Informal document **GRB-62-17**  
(62nd GRB, 1-3 September 2015,  
agenda item 7)

# **ETRTO comments on NL GRB-61-03**

**NL proposal for amending tyre noise limits  
in UN Reg. 117.03**

# Evaluation of tyre noise limits based on sold tyres in The Netherlands – C1 & C2 tyres

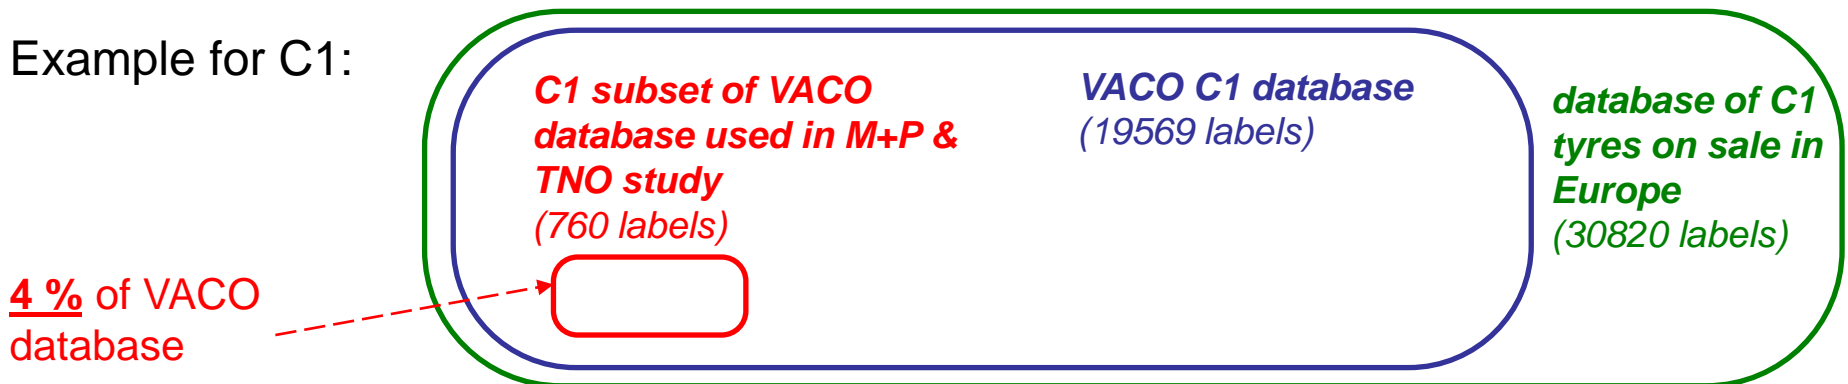
ETRTO considered the database from which NL extracted a subset for their studies and, in our view,:

- ❖ The VACO database is representative for the tyres on sale in Europe
- ❖ The subset of C1 & C2 tyres derived from the extraction of the 2013's VACO database is biased towards low noise and is not representative for the current VACO database.

# Evaluation of tyre noise limits based on sold tyres in The Netherlands – C3 tyres

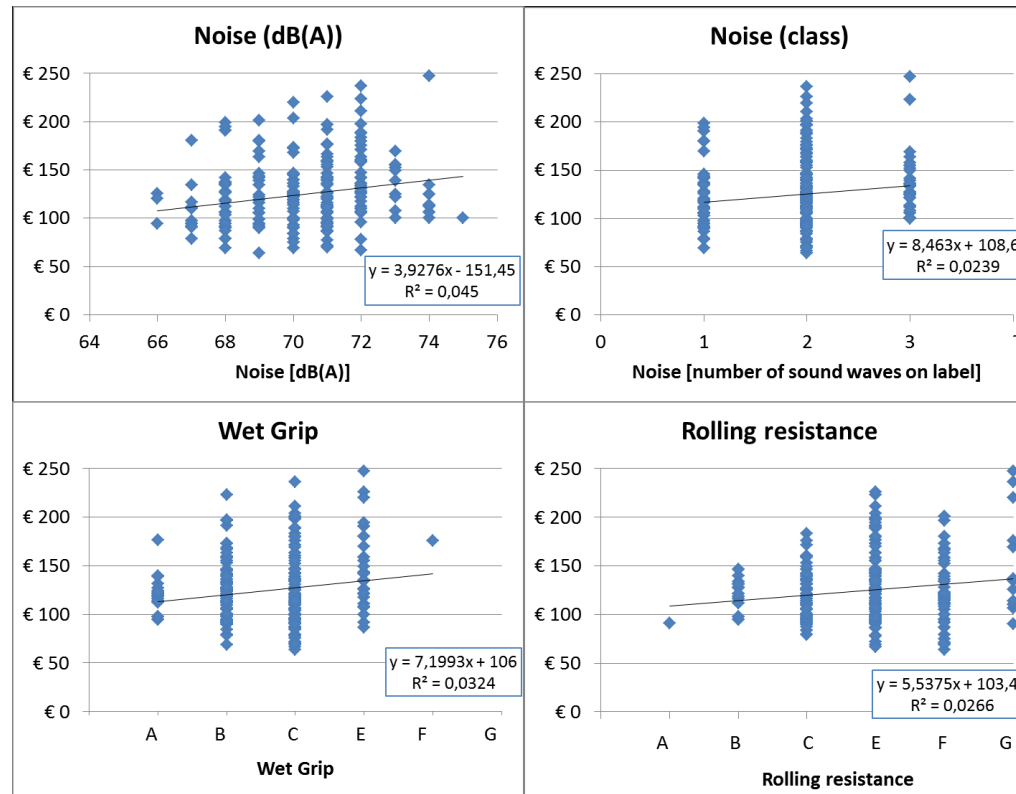
ETRTO considered the database from which NL extracted a subset in their studies and, in our view,:

- ❖ The subset of C3 tyres in the M+P and TNO study seems to have a similar distribution compared to the distribution of the C3 VACO database

# UN Regulation 117 IMPLEMENTATION STEPS

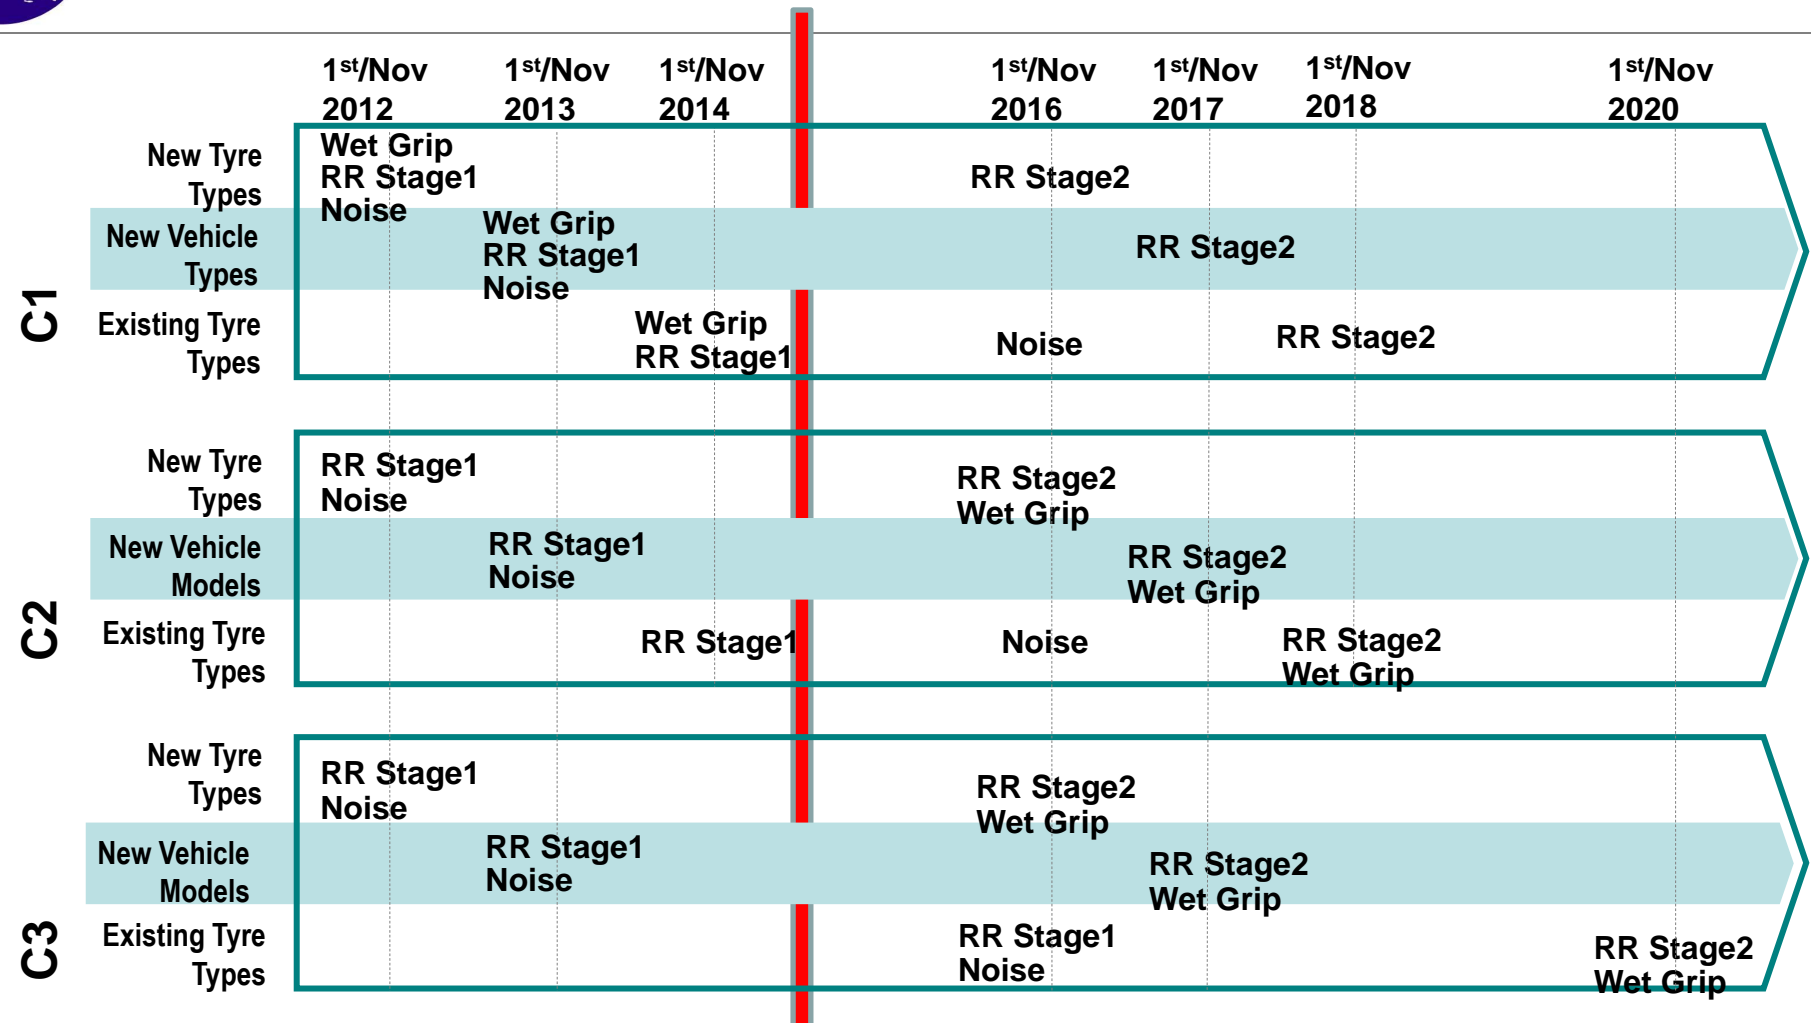
**A realistic State of Art and its assessment in terms of future potential for improvement can only be done when all the tyres complying to all UN Reg. 117.02 requirements are on the market.**
